City of Mississauga Department Comments

Date Finalized: 2021-10-26 File(s): A453.21

The applicant requests the Committee to approve a minor variance to allow the construction of an accessory structure (shed) with an interior side yard setback of 0.60m (approx. 1.97ft) whereas By-law 0225-2007, as amended, requires a minimum interior side yard setback of 1.20m (approx. 3.94ft) for an accessory structure in this instance.

Property Address: 1335 Madigan's Lane

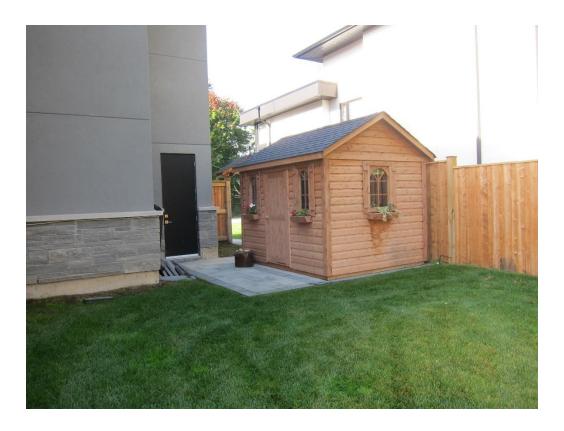
Enclosed for Committee's information are photos of the existing shed. Should Committee see merit in the applicant's request, we ask that the north side of the structure be equipped with an eaves trough and down spout directed in such a manor to not affect the neighbouring property to the north.
